Proposal for amendments to ECE/TRANS/WP.29/GRE/2013/50

Regulation No. 48

The text reproduced below was prepared by the expert from OICA to propose amendments to ECE/TRANS/WP.29/GRE/2013/50 by GTB. The modifications to ECE/TRANS/WP.29/GRE/2013/50 are marked in bold for new or strikethrough for deleted characters.

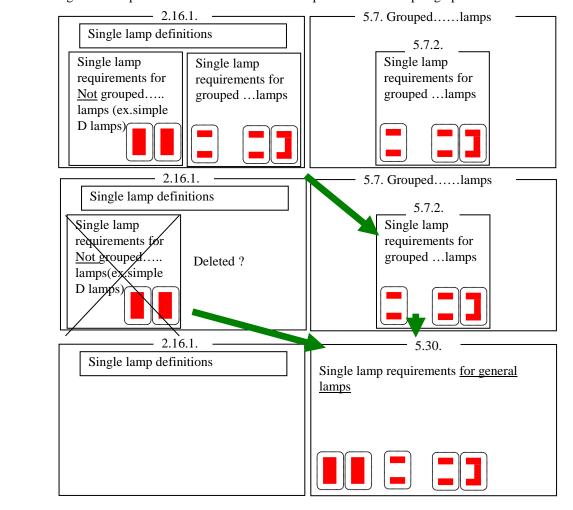
1. OICA supports the basic idea to move single lamp requirements from paragraph 2.DEFINITIONS to paragraph 5.GENERAL SPECIFICATIONS. But the requirements should not be under paragraph 5.7. "Grouped, combined or reciprocally incorporated lamps" because the single lamp requirements in paragraph 5.7.2. would be only for grouped, combined or reciprocally incorporated lamps. The single lamp requirements should be for general lamps. Therefore OICA moved the requirements to new paragraphs.
